**Explosives and related matters: review of tests in
parts I, II and III of the Manual of Tests and
Criteria**

**Manual of Tests and Criteria, review of Test Series H:
determination of self-accelerating decomposition
temperature**

Transmitted by the Chairman of the Working Group on Explosives

1. This document provides a marked-up copy of Section 28 of the Manual of Tests and Criteria, with the amendments proposed in document ST/SG/AC.10/C.3/2020/3-ST/SG/AC.10/C.4/2020/4.
2. All changes are indicated: inserted text is shown in red and deleted text in ~~red~~, ~~strikethrough~~.
3. The TDG and GHS sub-committees are invited to consider the proposed amendments for adoption.

Figure 28.4.2.2: Example of determination of SADT or SAPT

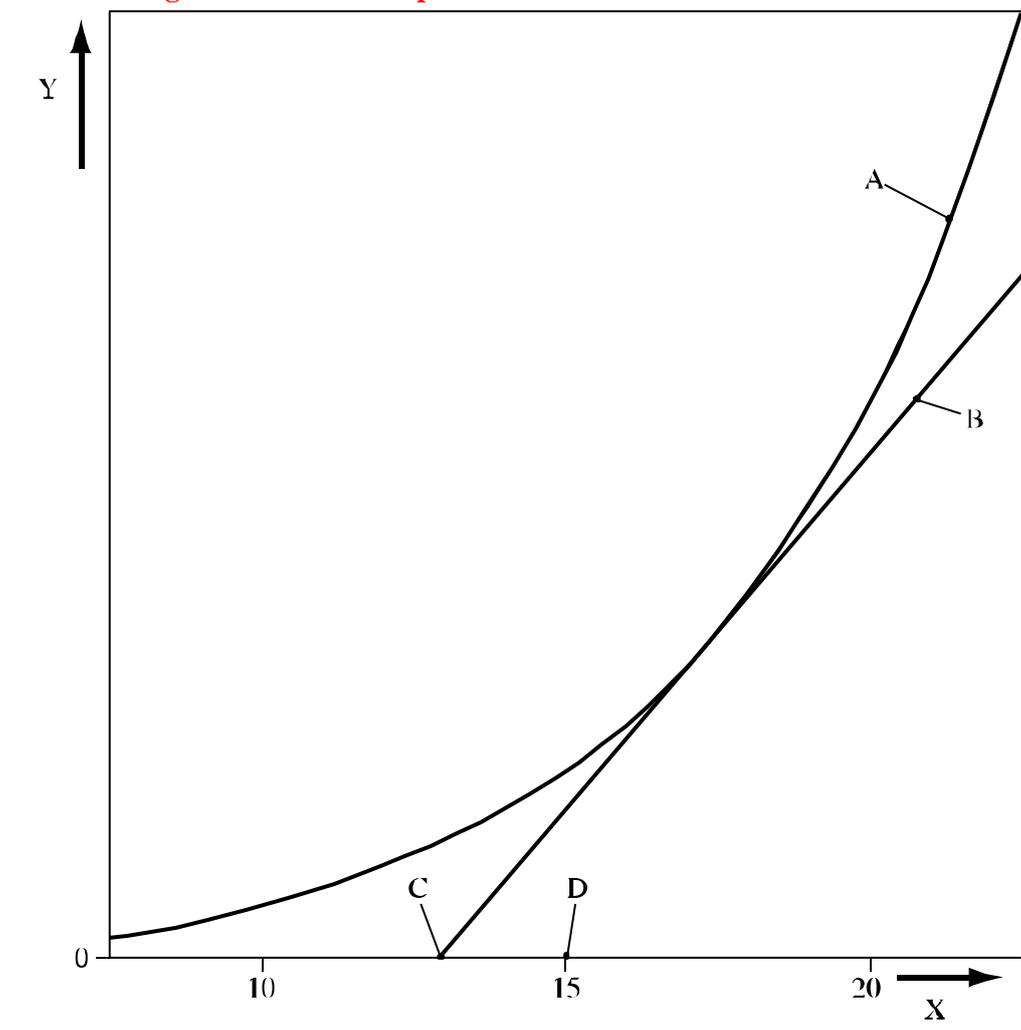
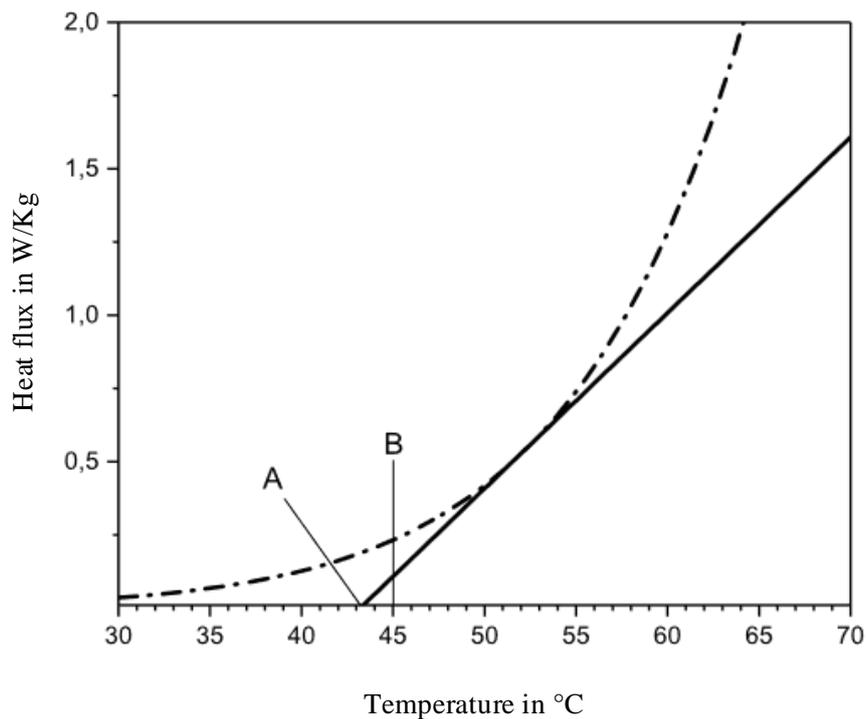
28.4.2.4.6 Plot the calculated rates of heat generation per unit of mass (Q_T) as a function of the temperature in a graph with linear scales and draw the best-fit curve through the plotted points. Determine the heat losses per unit of mass, L ($\text{W}/\text{kg}\cdot^{\circ}\text{C}$) of the specific package, IBC or tank (see 28.3.5). Draw a straight line of gradient L tangential to the heat generation curve. The intersection of the straight line and the abscissa is the critical ambient temperature, i.e. the highest temperature at which the substance as packaged does not show self-accelerating decomposition. The SADT is the critical ambient temperature ($^{\circ}\text{C}$) rounded to the next higher multiple of 5°C . An example is given in Figure 28.4.2.2.

Figure 28.4.3.2: Example of determination of SADT or SAPT

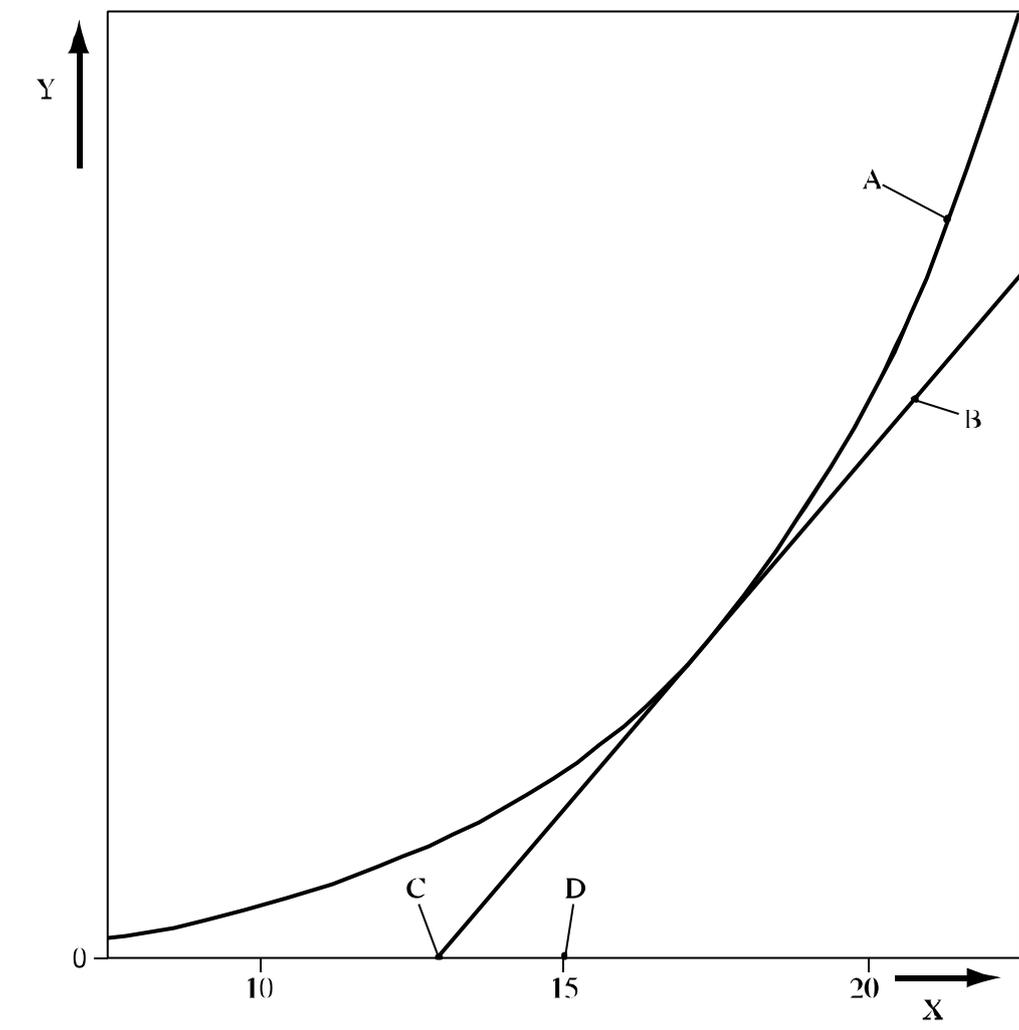
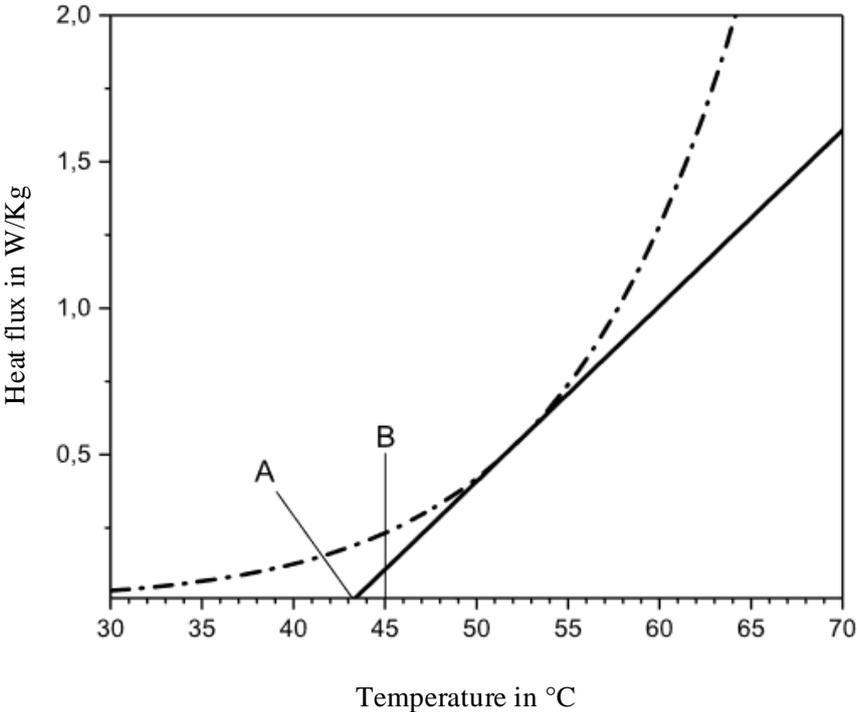
28.4.3.4.13 Plot the calculated maximum rate of heat generation per unit of mass as a function of the test temperature on a graph with linear scales and draw the best-fit curve through the plotted points. Determine the heat losses per unit of mass, L (W/kg.°C) of the specific package, IBC or tank (see 28.3.5). Draw a straight line of gradient L tangential to the heat generation curve. The intersection of the straight line and the abscissa is the critical ambient temperature i.e. the highest temperature at which the substance as packaged does not show self-accelerating decomposition. The SADT or SAPT is the critical ambient temperature (°C) rounded to the next higher multiple of 5 °C. An example is given in Figure 28.4.3.2.
